SUBJECT: NuScale Power, LLC Response to NRC Request for Additional Information No. 394 (eRAI No. 9407) on the NuScale Design Certification Application

REFERENCE: U.S. Nuclear Regulatory Commission, "Request for Additional Information No. 394 (eRAI No. 9407)," dated March 21, 2018

NuScale Response to NRC Request for Additional Information eRAI No. 9407

Figure 15.2-7: Reactor Pressure Vessel Pressure - Peak RCS Pressure Case (15.2.1-15.2.3 LOEL-TT-LOCV)

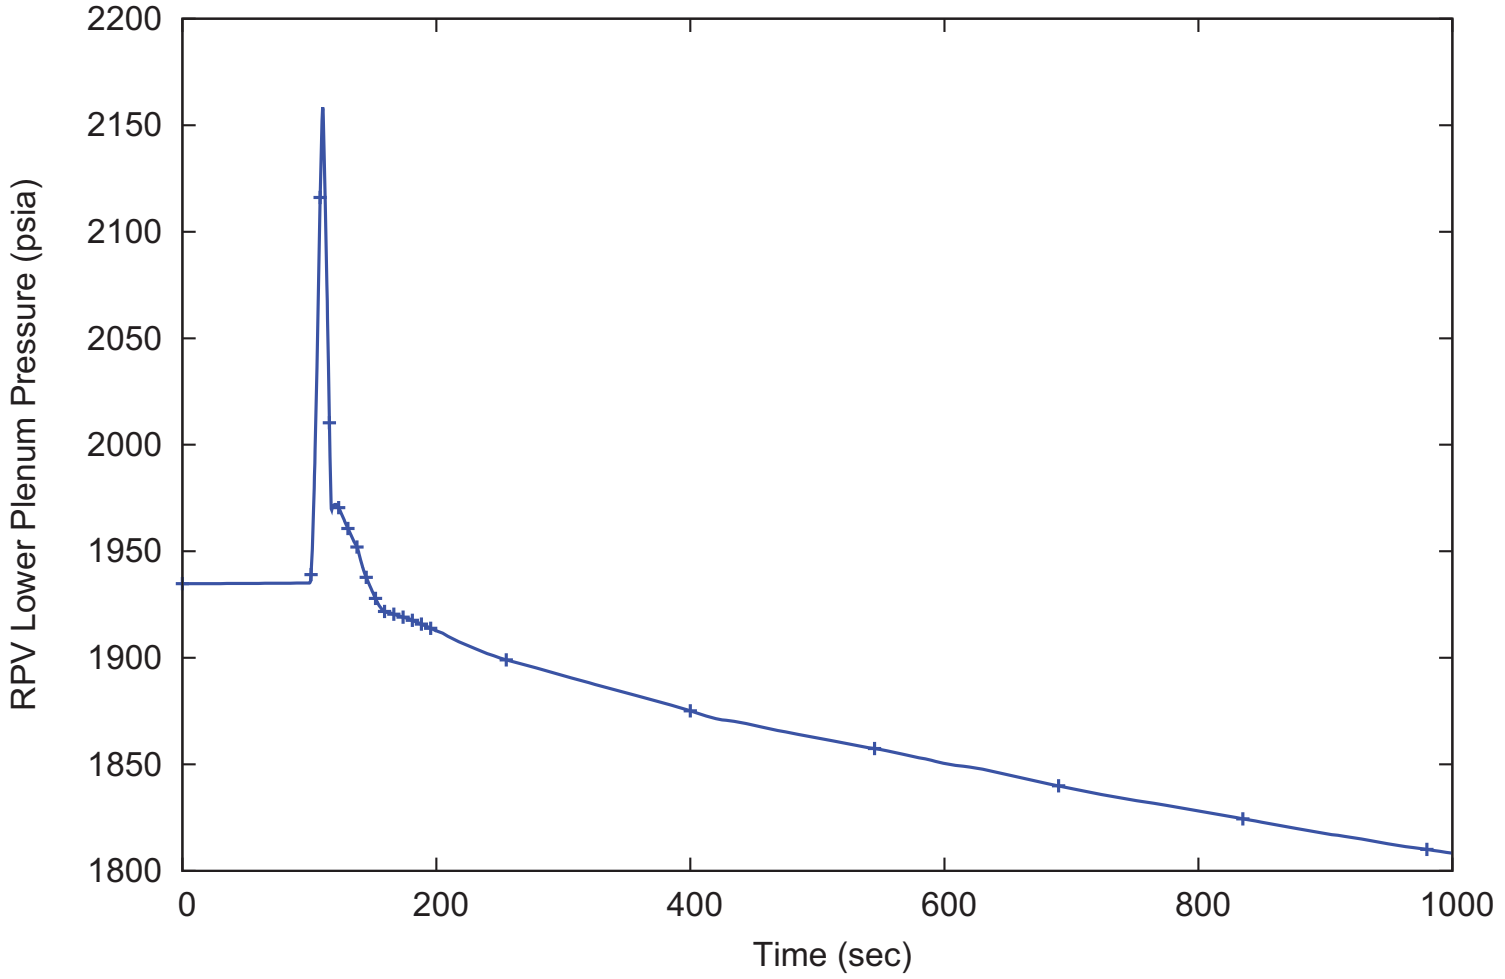
The staff notes that FSAR Figure 15.2-7 shows pressurizer pressure for the LOEL, TT, and LOCV maximum RCS pressure case, but the peak pressure shown in the figure is less than the maximum RCS pressure in FSAR Table 15.2-7 (2158 psia), presumably because the maximum RCS pressure occurs at a different location in the RCS. To allow the staff to verify the RCS pressure response for these events, please provide and add to the FSAR a new figure that shows the pressure response for the location of maximum RCS pressure for the LOEL, TT, and LOCV events.

The requested figure has been added to the FSAR to show reactor pressure vessel (RPV) lower plenum pressure for the limiting loss of external load (LOEL), turbine trip (TT) and loss of condenser vacuum (LOCV) reactor coolant system (RCS) pressure transient scenario.

FSAR Figure 15.2-7 has been revised as described in the response above and as shown in the markup provided in this response.
